DECEMBER 2006

EXPLANATION OF SIGNIFICANT DIFFERENCES

**Onondaga Lake Bottom Subsite
of the Onondaga Lake Superfund Site
Towns of Geddes and Salina, Villages of Solvay and Liverpool, and City of Syracuse,
Onondaga County, New York**

FIGURE 3

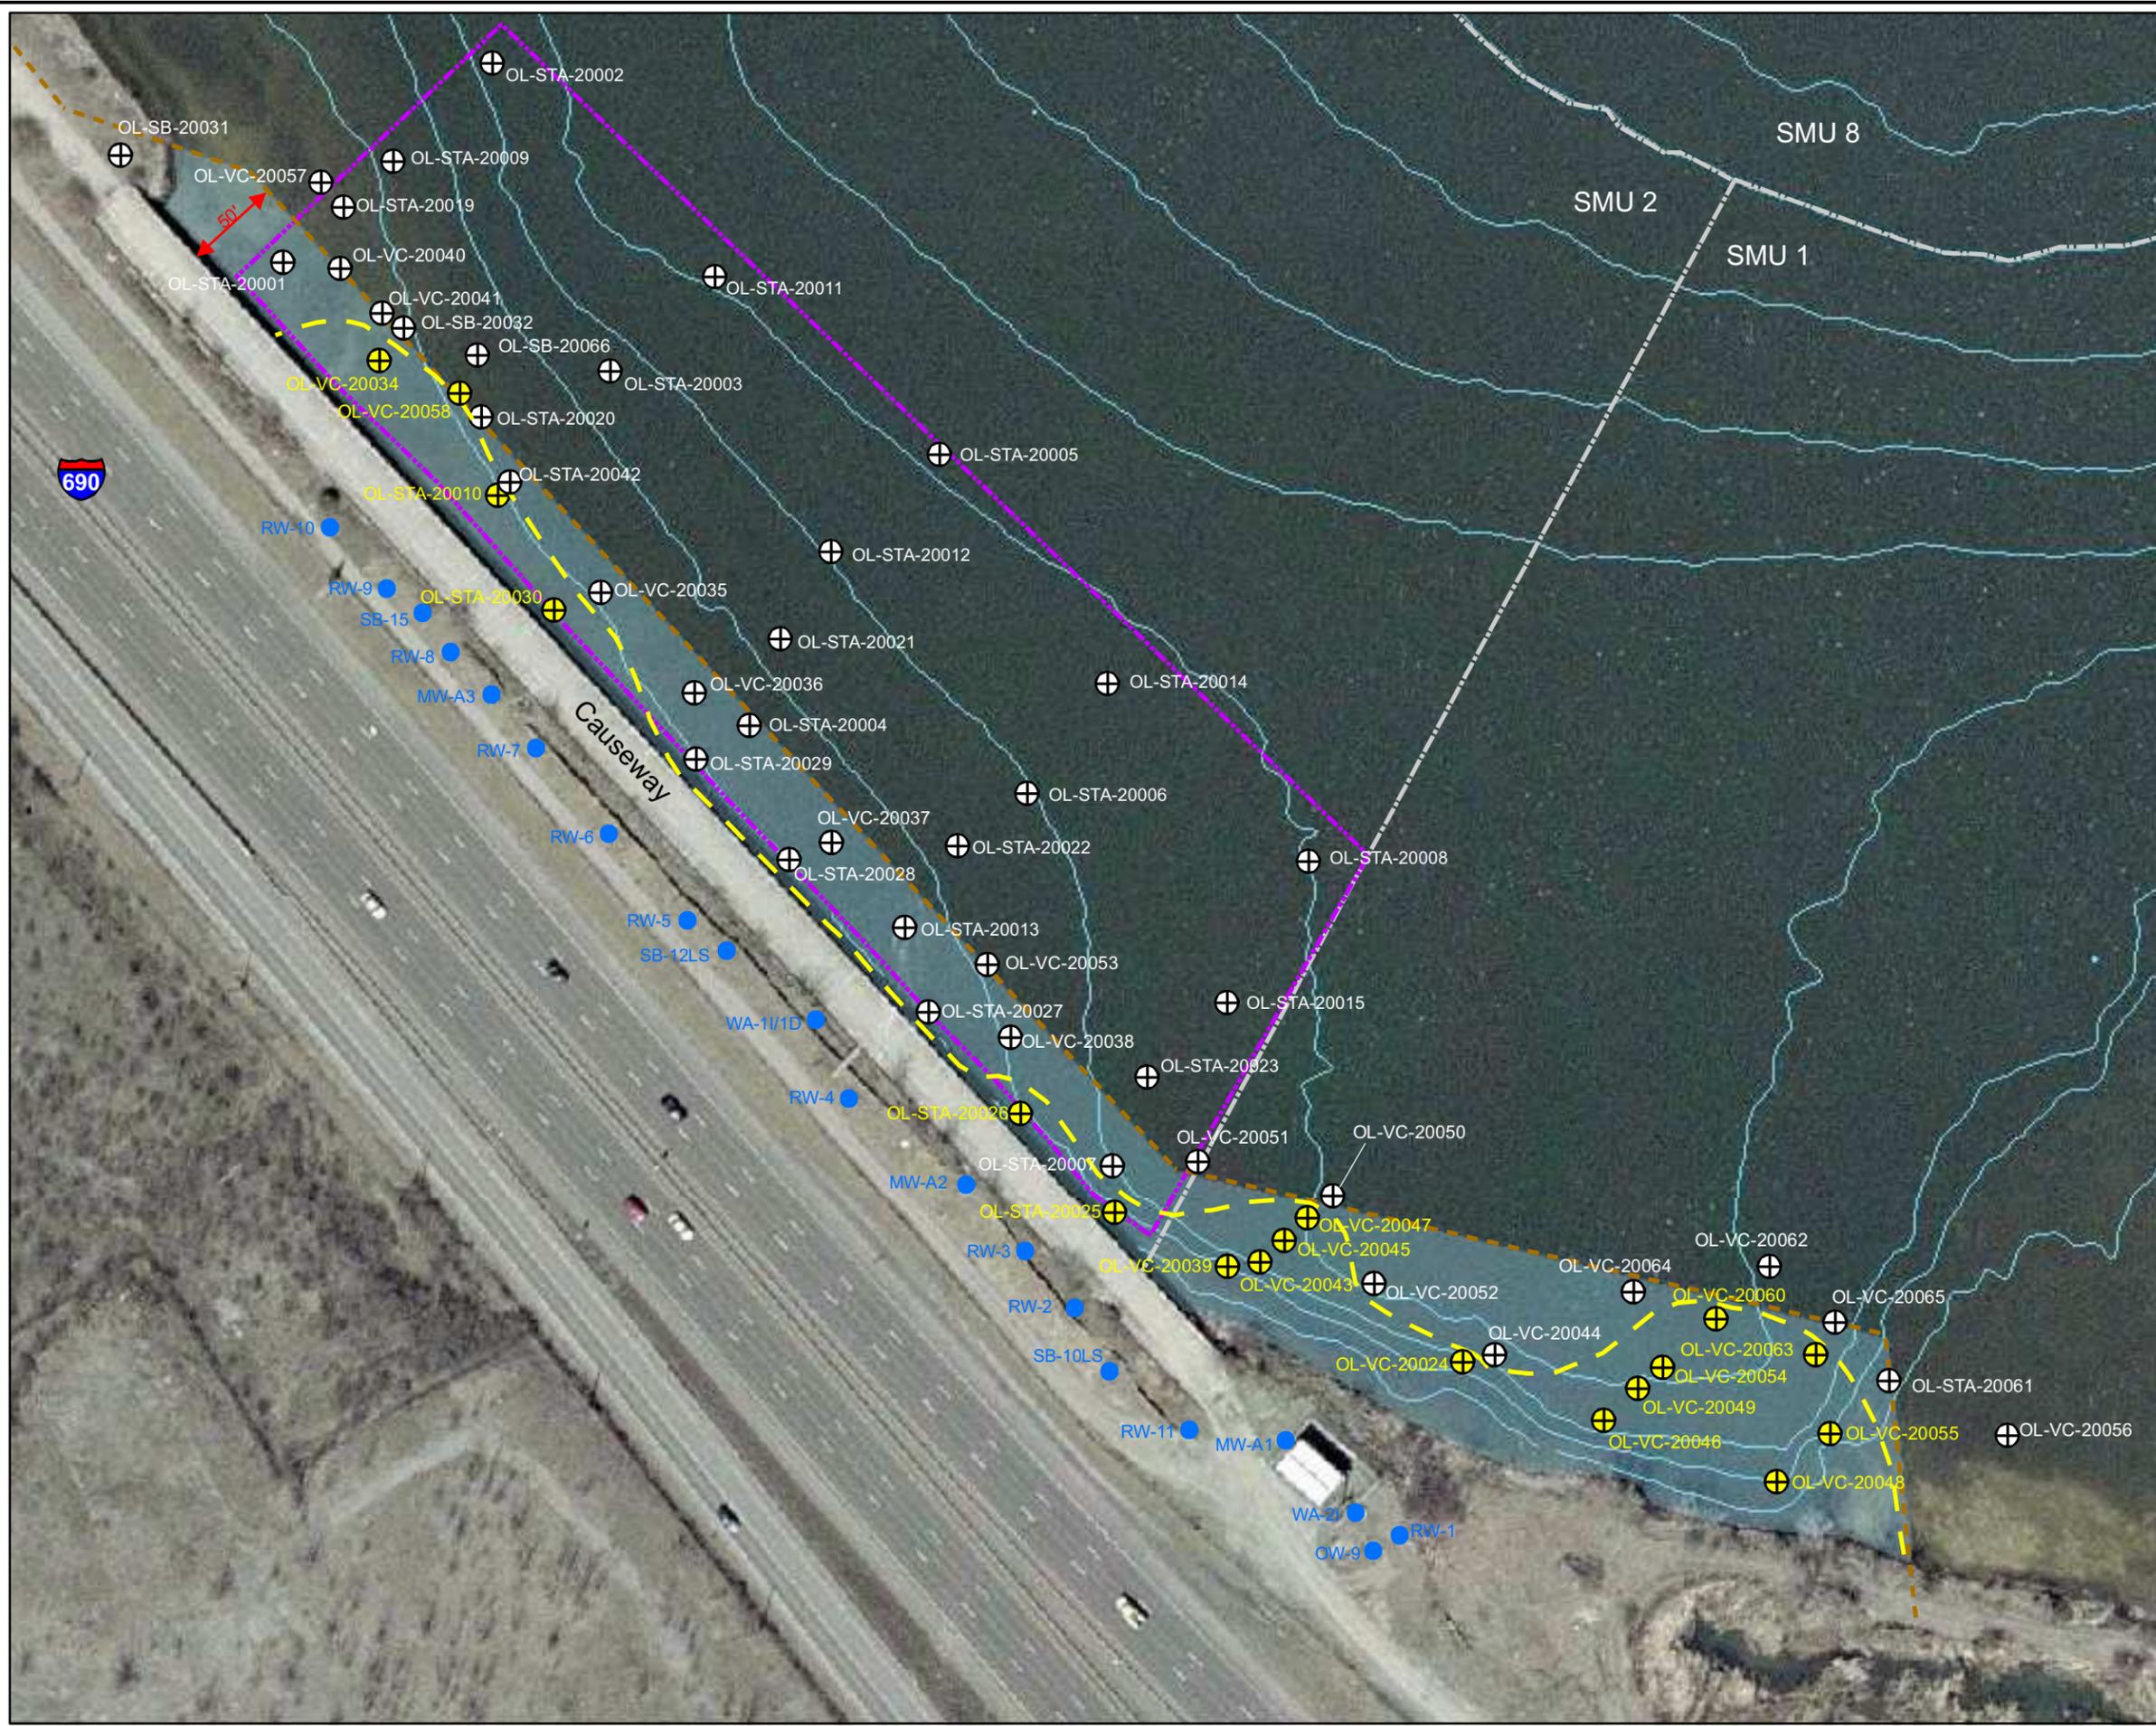
Subsequent to the issuance of the ROD, an extensive pre-design investigation was conducted in SMU 2 in the Fall of 2005 and the Spring of 2006 to identify the extent of pooled NAPLs and to characterize the subsurface conditions. Based on these investigations, it was determined that NAPLs in the causeway area extend a short distance into the adjacent SMU 1, but the overall extent of pooled NAPLs beneath the lake bottom in SMU 2 is significantly smaller than was anticipated. The ROD assumed that the NAPLs were present beneath the lake bottom over an area of approximately 4.8 acres. The pre-design investigation results indicate, however, that the NAPLs extend over an area of approximately 2 acres which includes the causeway area in SMU 2, and an adjacent portion of SMU 1. (See Figure 3.)

The ROD assumed that the NAPLs extended to a depth of approximately 30 feet beneath the lake bottom. However, the pre-design investigation results indicate that the pooled NAPLs frequently exist as a single layer at a depth below the lake bottom that is typically in the 15- to 25 feet range. The average thickness of the NAPLs is less than 2 feet. As a result, there is significantly less volume of NAPLs-impacted material beneath the lake in SMU 2 than was assumed during the FS and ROD. While the ROD assumed that there were approximately 233,000 cy of NAPLs present within SMU 2, the pre-design investigation results indicate that the actual quantity of NAPLs present within SMU 2 (and the adjacent portion of SMU 1) is approximately 5,000 cy. This is a conservative estimate as it assumes that NAPLs are present across the entire area that would be contained by the barrier wall.

In light of the pre-design results discussed above, the potential dredge removal volume associated with removing NAPLs in this area is significantly less than that assumed in the ROD. More specifically, approximately 157,000 cy of sediments would need to be dredged from SMU 2 (and the adjacent portion of SMU 1) in order to remove the NAPLs. This value includes the NAPLs volume, as well as the volume of materials that are present above the NAPLs, and the sloughing and over dredge volumes.

Dredging of the NAPLs in the causeway area would require dredging immediately adjacent to the shoreline barrier wall which will be installed as part of the Willis/Semet IRM. The ROD assumed that the barrier wall would be constructed adjacent to the lake. However, during design of the wall, it became evident that the presence of utilities beneath and adjacent to the causeway would preclude the installation of the barrier wall on the landward side of the causeway. Therefore, it was determined that the eastern portion (the causeway portion) of the barrier wall should instead be installed on the lakeside of the causeway, but as close as possible to the existing causeway (i.e., 15 to 20 feet into the lake). The data collected as part of the pre-design investigation in 2005 allowed

an evaluation of the stability of this wall during dredging. The stability of the wall and the adjacent upland area is particularly critical due to the presence of a major sewer pipeline, other utilities, and interstate highway, I-690, immediately adjacent to the shoreline. This stability evaluation indicated that the barrier wall and adjacent upland area would be potentially unstable and could collapse during dredging to the depth required to remove the NAPLs as called for in the ROD. The only reliable way to achieve a stable wall would be to install the barrier wall through the clay layer beneath the NAPLs. Installation of the wall through the clay layer, however, could provide a pathway for the NAPLs to migrate into deeper zones. Due to the risk of producing such a pathway, penetrating the clay with a barrier wall is not a preferable option.

Based on the new data and the stability evaluation, the most appropriate remedy to address NAPLs in the causeway area in SMU 2 and the adjacent area in SMU 1, is to locate the Willis/Semet IRM barrier wall off-shore immediately beyond the furthest extent of pooled NAPLs within the lake (See the Figure 3.) and to install additional NAPLs recovery wells (to supplement the existing NAPLs recovery system) between the barrier wall and the causeway. The wall will be tied into the underlying clay layer and clean fill will be placed behind the wall. This will eliminate the need for dredging to address pooled NAPLs within SMU 2 and in the adjacent area within SMU 1, and will address the geotechnical stability concerns while being protective of public health and the environment. The NAPLs will be completely isolated from the lake. The additional NAPLs recovery wells will be installed behind the wall as part of the Willis/Semet IRM and on the northwestern area of the Wastebed B/Harbor Brook subsite to enhance the recovery of NAPLs present in the subsurface. Recovered NAPLs will be treated and/or disposed of off-site.
